Candidate text for Annex 93A, Clause 110 and Clause 111

Adee Ran

Figure 110-3—Interference tolerance test setup

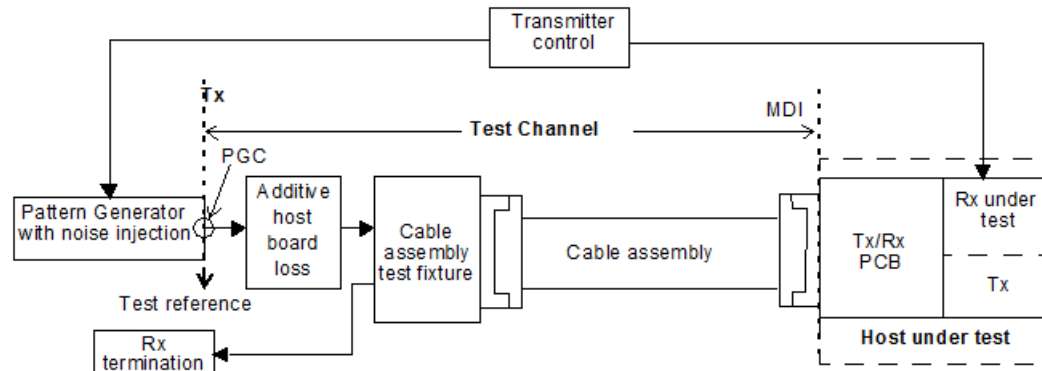
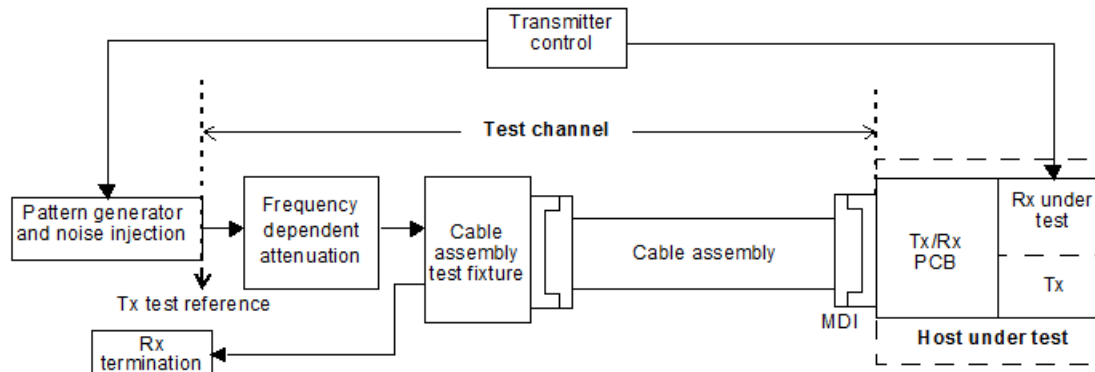
The interference tolerance test is performed with the setup shown in Figure 110–3. The requirements of this subclause are verified at the ~~pattern generator connection (PGC) or~~ test references in Figure 110–3 and Figure 110–4. The cable assembly unused single-ended paths are terminated in 50 Ω to provide 100 Ω differential termination.

The test channel ([depicted in Figure 110–3](#)) consists of the following:

- a) A cable assembly (~~see meeting the requirements of 110.10) that meets~~ ^{and} the ~~cable assembly COM~~ [fitted insertion loss](#) specified for the test being performed.
- b) A cable assembly test fixture (see 110B.1.2 and ~~92.11.2~~).
- c) ~~A connecting path from the pattern generator to the cable assembly test fixture.~~
- d) [A frequency-dependent attenuator.](#)

NOTE—The [frequency-dependent attenuator](#) represents the host channel and may be implemented with PCB traces and test cables.

NOTE—The MDI of the host under test is not included in the test channel.

Figure 110-4—Test channel calibration

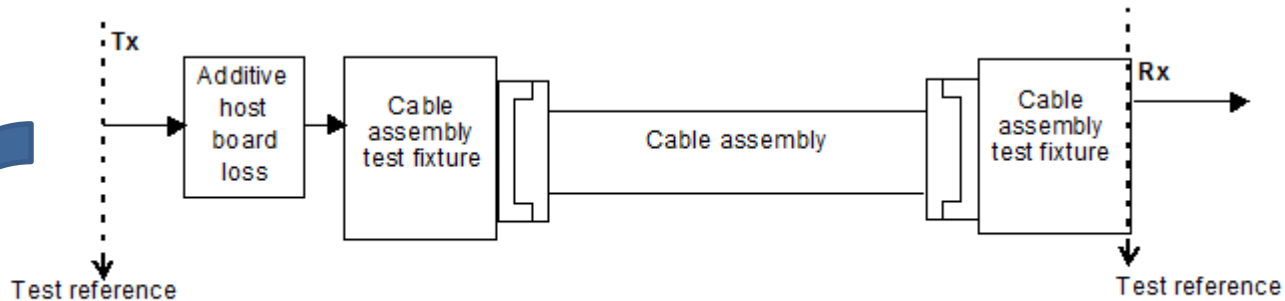
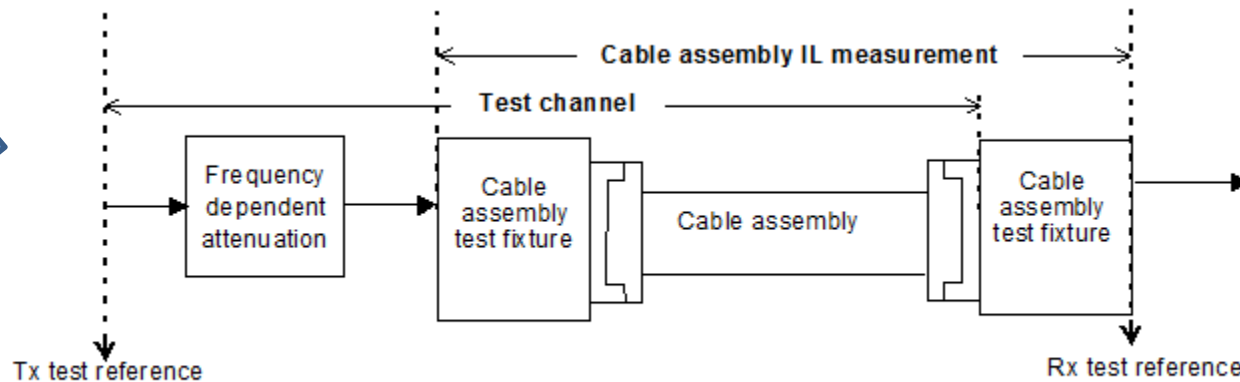
Clause 110 test setup/channel i-71, i-74

The fitted insertion loss ~~coefficients~~ at 12.8906 GHz of the signal path between the reference points in 110-4, derived using the fitting procedure in 92.10.2, shall ~~meet~~ be within the ~~values~~ limits in Table 110-5, Table 110-6, or Table 110-7, as appropriate for the test being performed. ~~It is recommended that the deviation between the insertion loss and the fitted insertion loss be as small as practical and that the fitting parameters be as close as practical to the values given in the table.~~
